SP ENERGY NETWORKS

Product Recall
Lucy Electric Solid Link for N2 LV Pillars

Figure 1. Link too tight for phase contacts

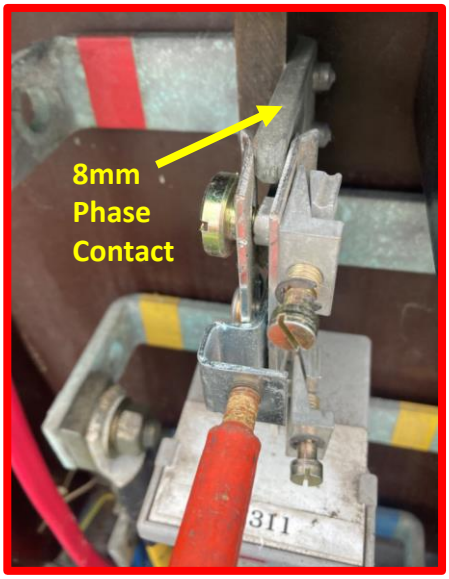
The thickness of the pillar phase contacts is 8mm (See Figure 1) and the gap between the mating faces of the solid link have been found to be 6.5mm. By design, there should be an adequate tolerance within the link assembly to allow the plates to be pushed over the mating pillar phase contacts. The Thackery washer (See Figure 3) then helps to hold the link in position (in addition to the operator holding the link in position), to allow it to be then tightened onto the contacts via the wedge clamps when using an approved insulated screwdriver.

Lucy Electric has concluded that the issue has been caused by a tooling manufacturing error (estimated from February 2019) that has caused the Thackery washer to be over compressed by the central rivet, which removes the required movement from the assembly. (See Figure 1 & 2)

- Modifying or reworking affected solid links by removing the Thackery washer is not permitted.
- Operational staff shall carry out a visual inspection of their stock of solid links to ensure that the Thackery washer in not over compressed and to ensure that there is a minimum gap of 8mm between the contact plates. If affected solid links are found to have an over compressed Thackery washer or a gap of 6.5mm, they shall be returned to either Bonnybridge (SPD) or Queensferry (SPM) stores, where they will be quarantined and returned to Lucy.
- Any affected links found in stock or installed / stored in Lucy Electric N2 pillars shall be replaced with new solid links (See Figure 3) which will be issued via Logistics (SAP Code 30980746).
- All Team Leaders / Line Managers to ensure this recall process is undertaken.
